Re: A request by Robert Kauth for approval of the Final Plat of Kauth's 2nd Addition a thirteen (13) lot residential subdivision located west of 95th Avenue and south of Hickory Hills Second Annex in part of the NE¹/₄SW¹/₄ of Section 15, Buffalo Township.

PLANNING & ZONING COMMISSION STAFF REPORT

Request: Final Plat of Kauth's 2nd Addition, a proposed thirteen (13) lot residential

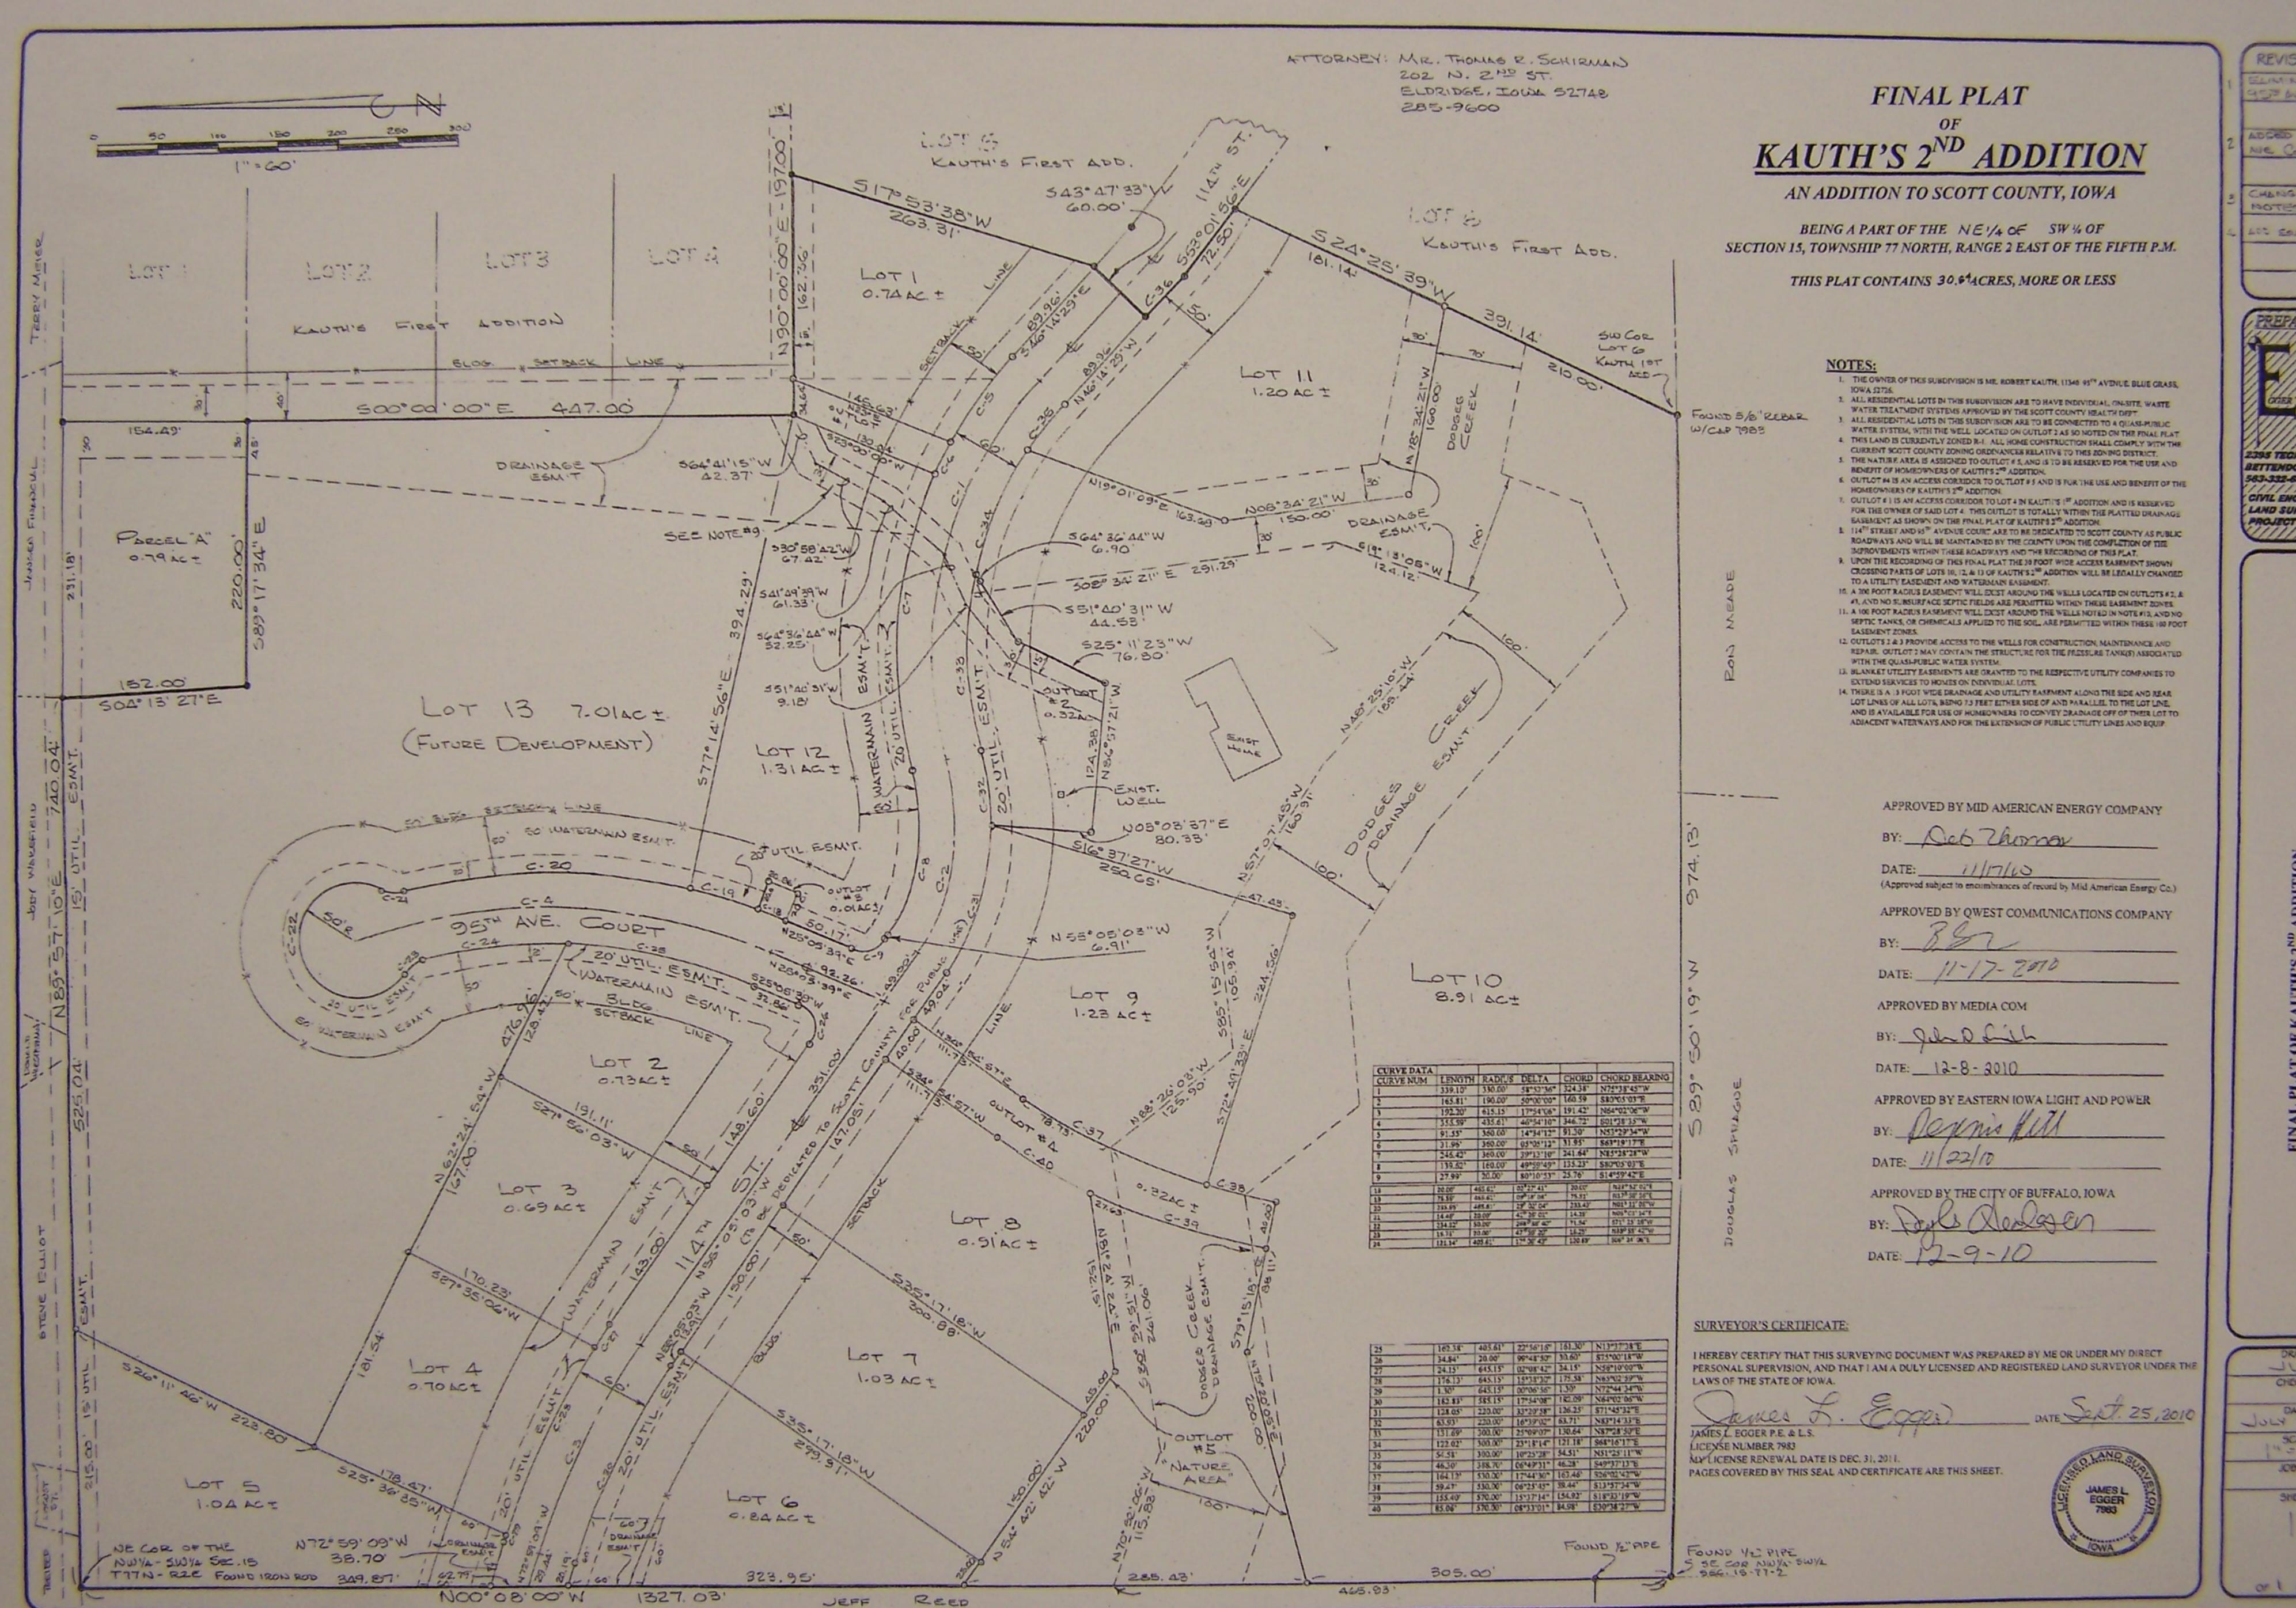
The County Engineer states that the new roads, 114th Street and 94th Avenue Court, appear to have been adequately constructed. However the County Engineer does state that he has concerns that he never received, reviewed or approved any final construction plans for that road. He did review Preliminary Plans and he states that the road construction appears to match those plans. He also states that the grades for 114th Street are nearly 7% in spots which was steeper than was shown on the plans. Finally he states that the road design is not consistent as far as the use of curb and gutter and that the standard for the County to accept subdivision roads is that they have curb and gutter throughout. He states that this would influence his recommendation on whether the County Board should accept these roads onto the County's system.

As far as the other conditions of Preliminary Plat approval the grading and road construction have complied with the erosion and sediment control plan, the limits for the drainage easements for Dodges Creek and its tributary to the north are shown on the affected lots, along with the front yard setback lines and finally all the proposed wastewater treatment facilities will meet Health Department requirements at the time houses and septic systems are constructed on each lot.

RECOMMENDATION: Staff recommends that the Final Plat for Kauth's 2nd Addition be approved.
